**COMMUNITY DEVELOPMENT  
DEPARTMENT REPORT**

APPLICANT: Connor Lindstrom, KM Engineering, LLP

SUBJECT: Durango Subdivision – AZ, PP  
H-2025-0017

# B. Conceptual Office Layout and Preliminary Plat (date: 1/5/2026)

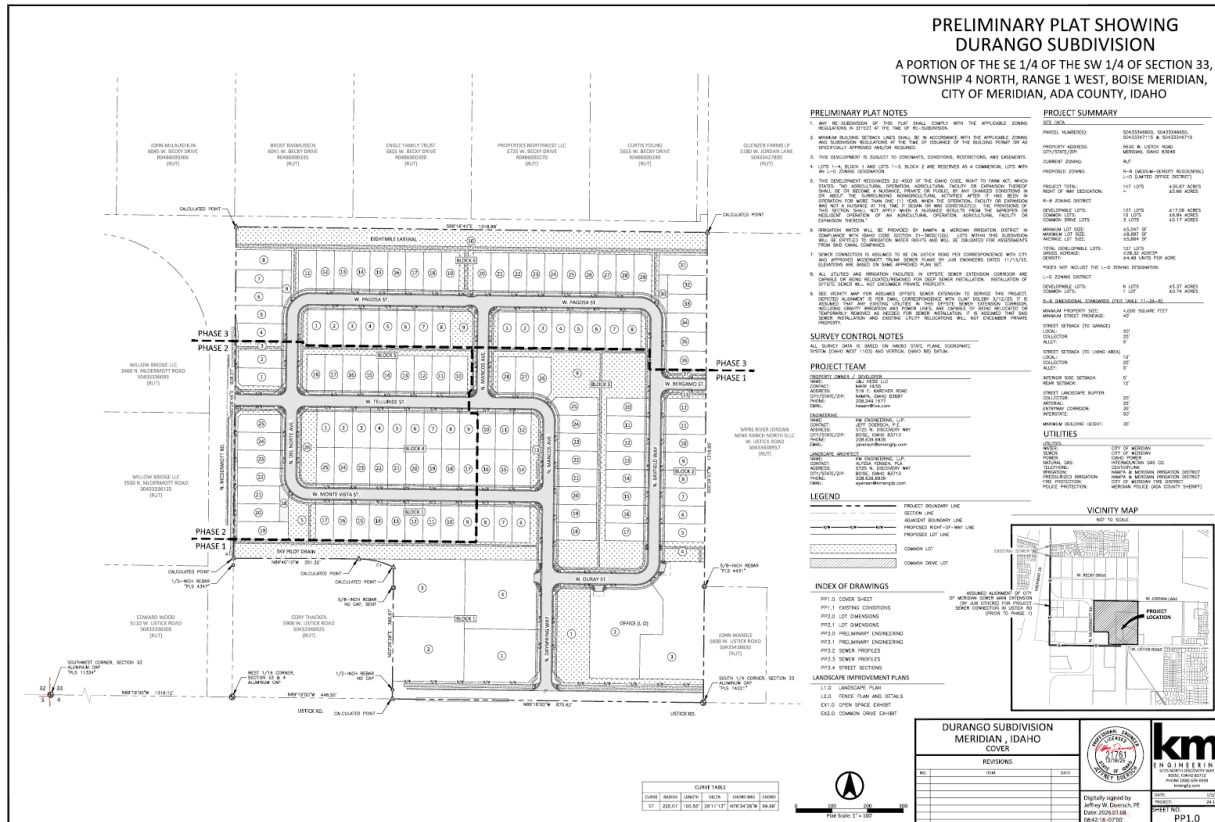
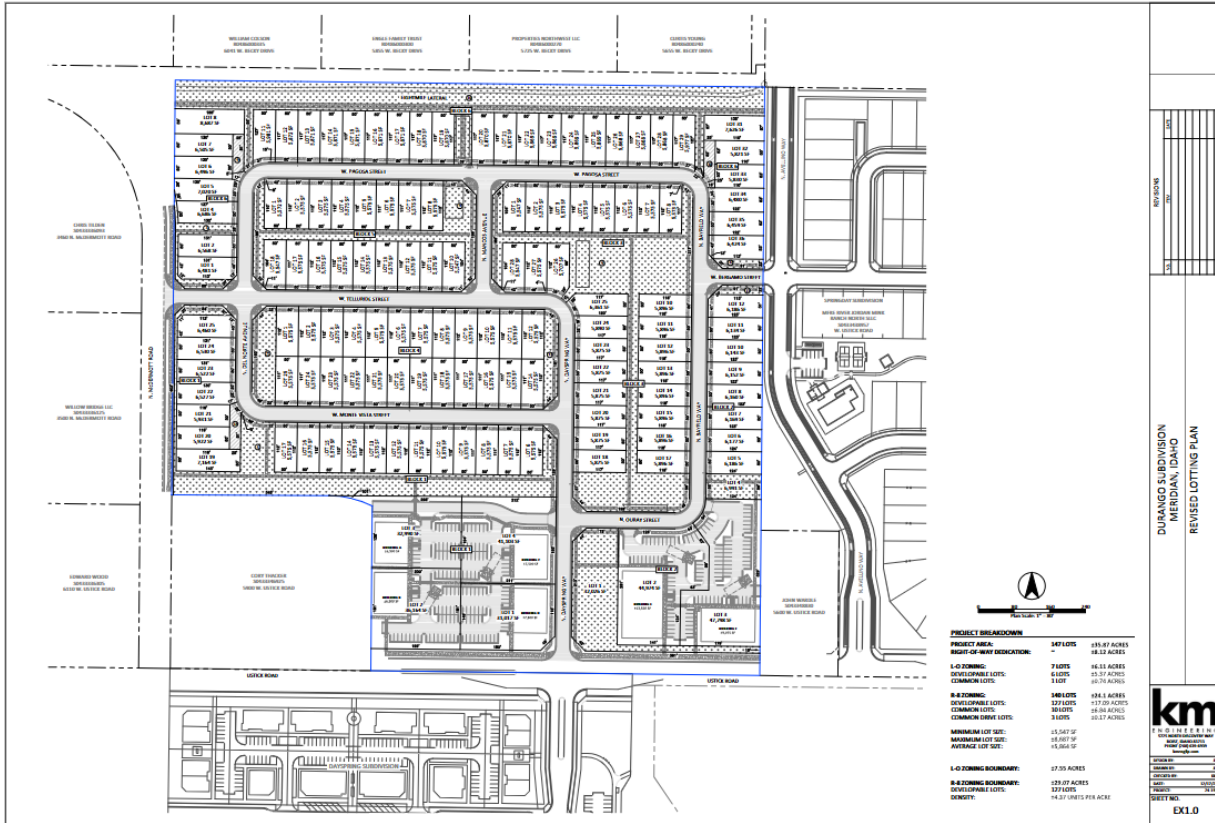
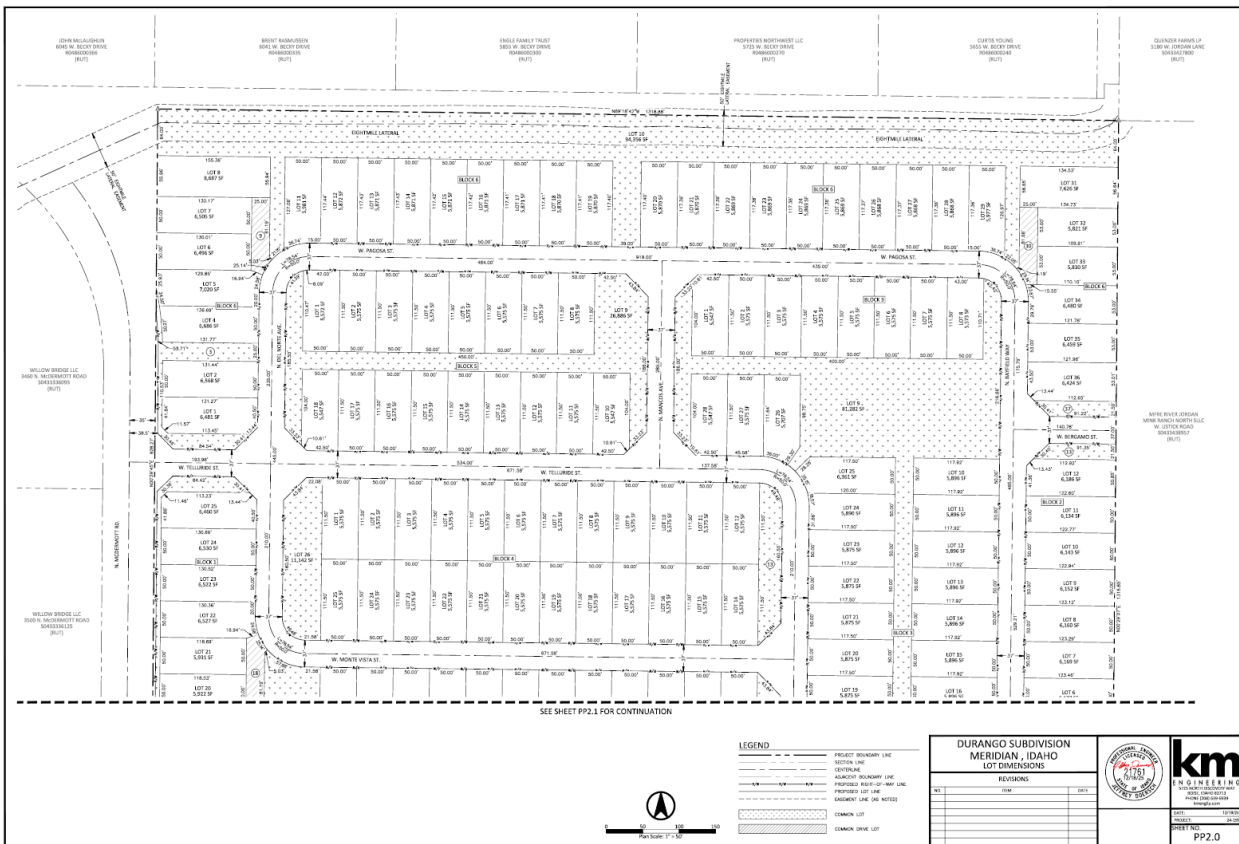
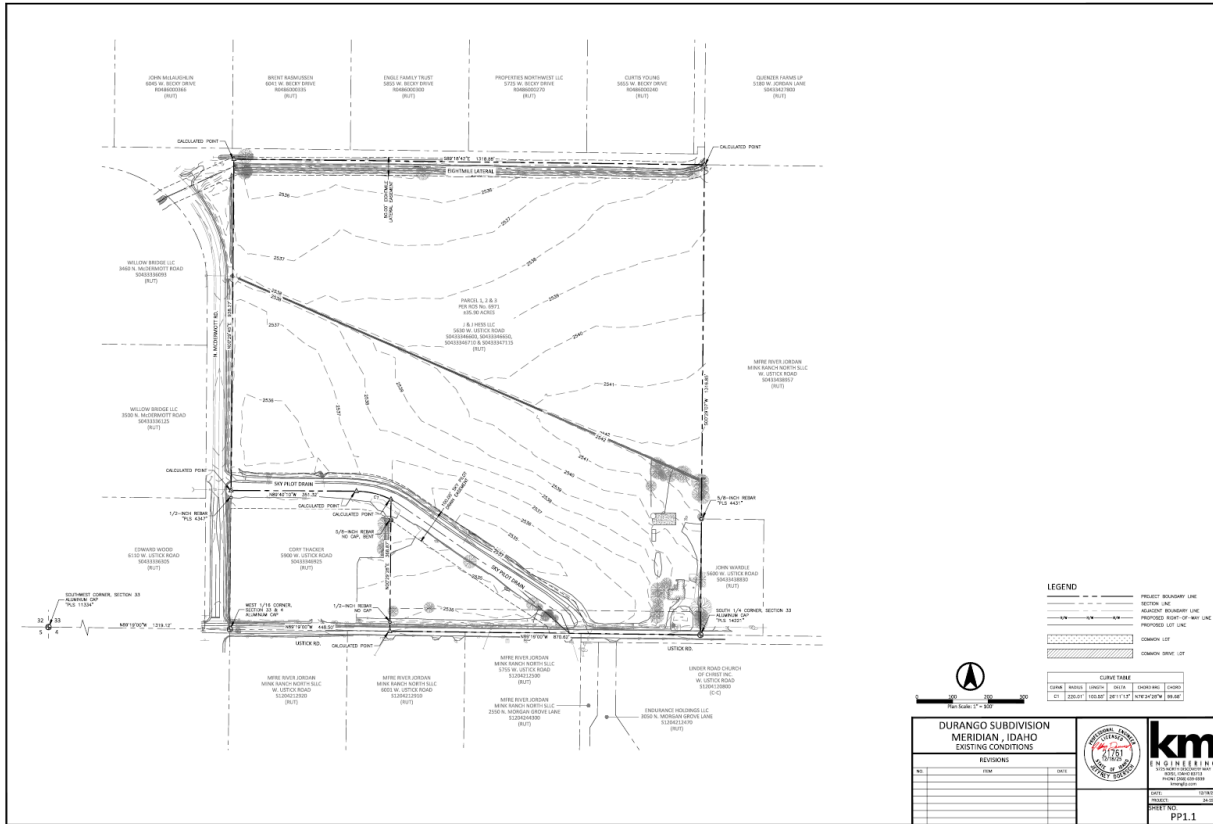
*Lots 1, 2, 4, Block 1 should graphically depict the 35-foot landscape buffer along Ustick Road and a 10-foot landscape buffer along N. Dayspring Way.*

**Where the pathway crosses a vehicular driving surface (driveway that parallels the Sky Pilot Drain), the applicant should distinguish this pedestrian crossing through the use of pavers, colored or scored concrete, or bricks, per UDC 11-3A-19B.4b.**

*Although the applicant exceeds the required amenities per the UDC, staff believes with this annexation the applicant should provide an additional amenity in one of open space commons lots. If these areas are for play for the residents, staff recommends the applicant construct a passive amenity such as an open space commons shelter in Lot 9, Block 3.*

*The north side of W. Pagosa Street exceeds 750 feet in length requirement but does not exceed 1,000 square feet in length. Per UDC 11-6C-3.F.1.a, where a pedestrian connection is provided, the maximum block face may be extended up to one thousand (1,000) feet in length in residential districts. The applicant is proposing multiple pathway connections, including traffic calming as required by the UDC. Therefore, staff has no opposition to the extended block length.*

- b. Add a note on the final plat(s) that states direct lot access is prohibited.
  - c. Lots 1, 2, 4, Block 1 shall graphically depict the required landscape buffer widths along Ustick Road and N. Dayspring Way.

- f. The applicant shall provide an open space commons shelter in Lot 9, Block 3. A detail of said amenity shall be submitted with the final plat application.

- g. Where the pathway crosses a vehicular driving surface (driveway that parallels the Sky Pilot Drain), the applicant shall distinguish this pedestrian crossing through the use of pavers, colored or scored concrete, or bricks, per UDC 11-3A-19B.4b.

**08 BOULDER INSTALLATION DETAIL**

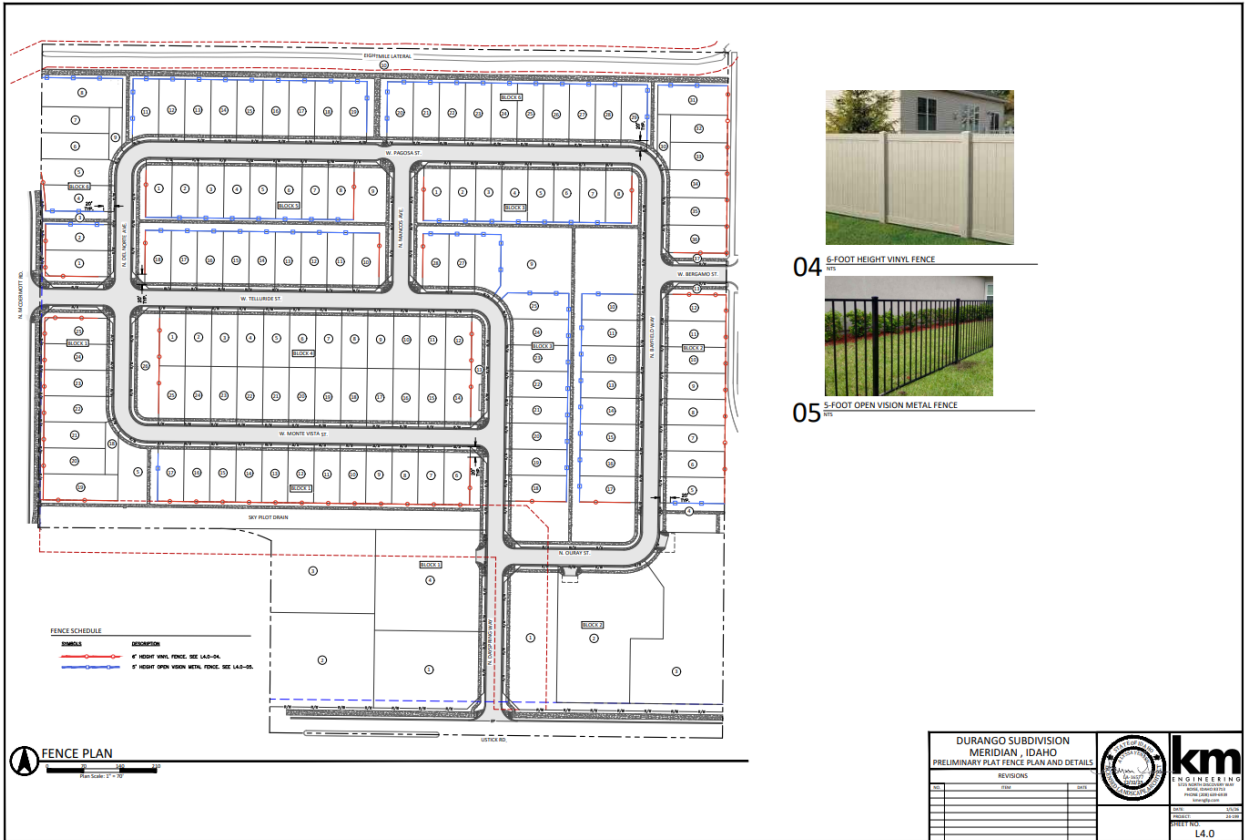
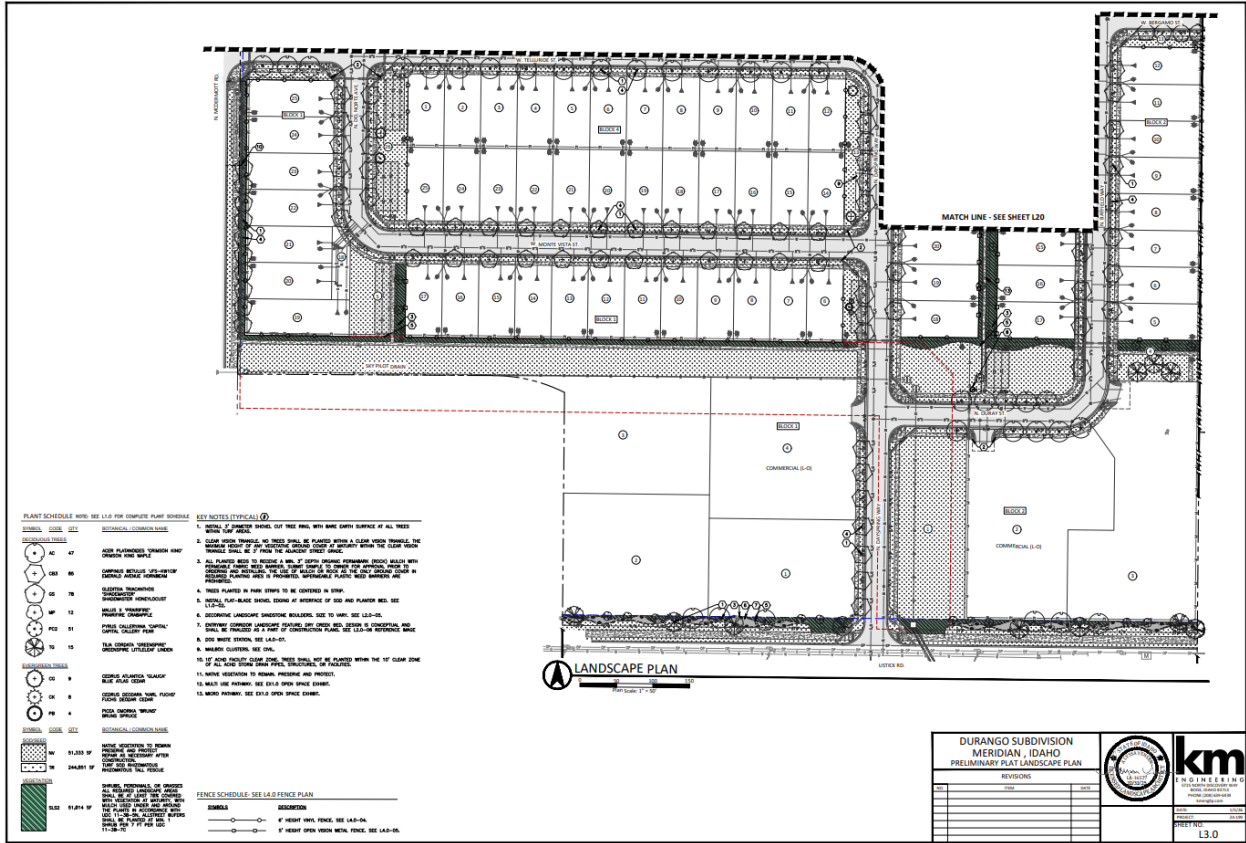
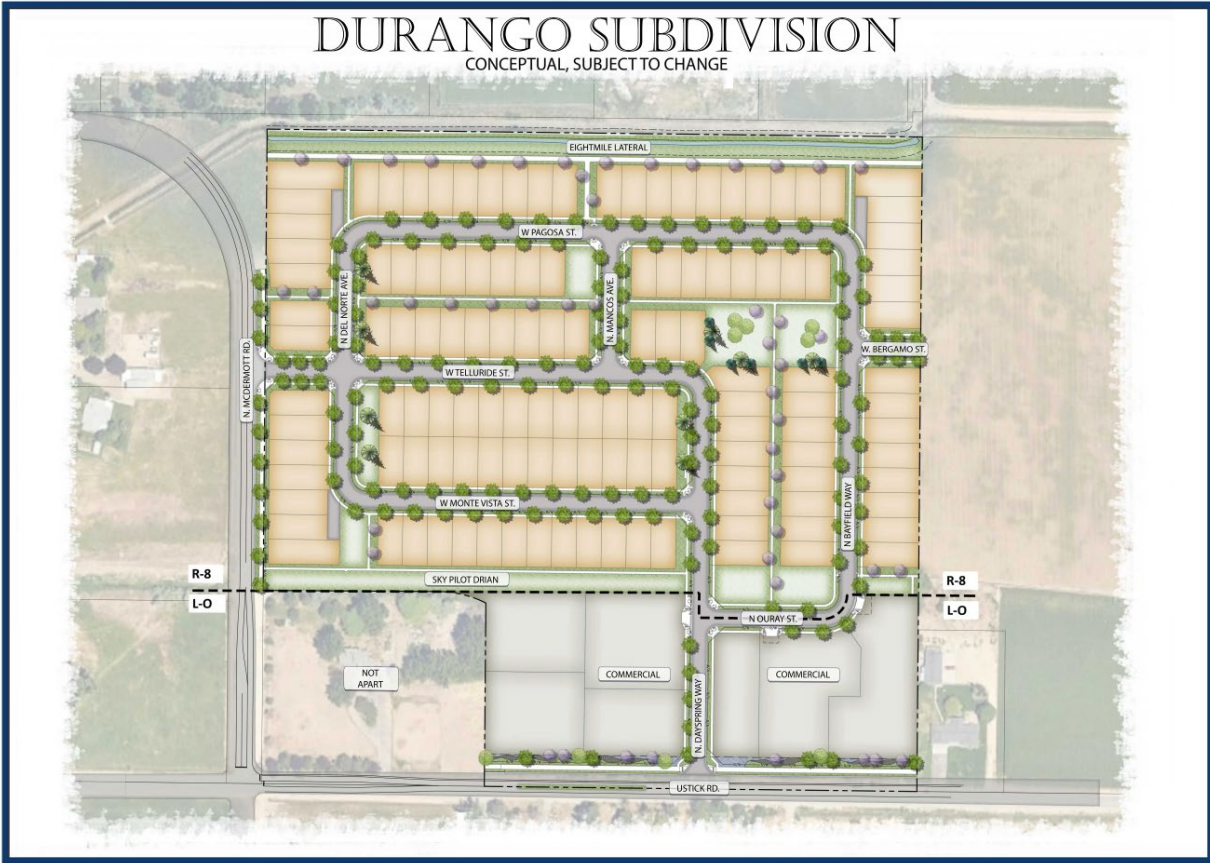
- h. Additional design features consisting of a dry creek bed with river rock and boulders shall be included in the street buffer along W. Ustick Rd., an entryway corridor, as proposed, in accord with UDC 11-3B-7C.3f.
